# Access Compliance Report

## Public Rights-of-Way

| Intersection ID: 14071                  | Main Street: CLEVELAND_AV | Cross Street: E_KINGSTON_AV             | Location: N            |
| ADA ID: D61BF9FB6427                    | Ramp Type: Directional1   | Initial Pass/Fail: Fail                 | Overall Compliance: No |

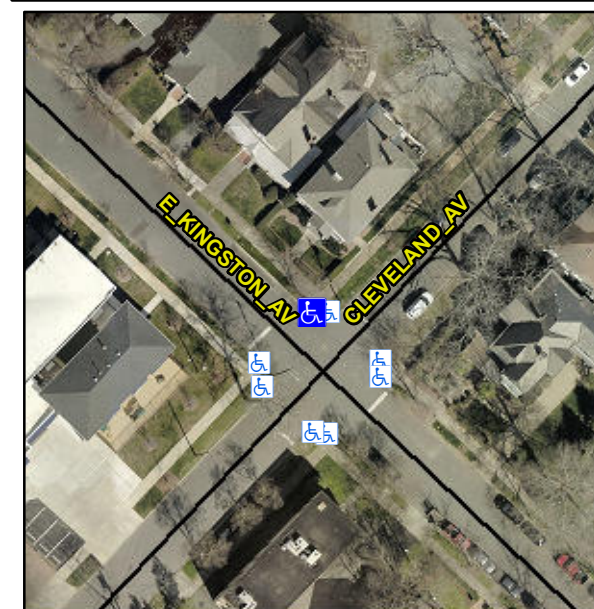
**R304.2.2, R304.5.3**

| Compliance | Description           | Data  | Compliance | Description                 | Data |
|------------|-----------------------|-------|------------|-----------------------------|------|
| No         | Ramp Slope (%)        | 9.3   | N/A        | Grade Break XSlope (%)      | 0.0  |
| No         | Ramp XSlope (%)       | 2.2   |            |                             |      |

**Remove & Replace Entire Ramp.**
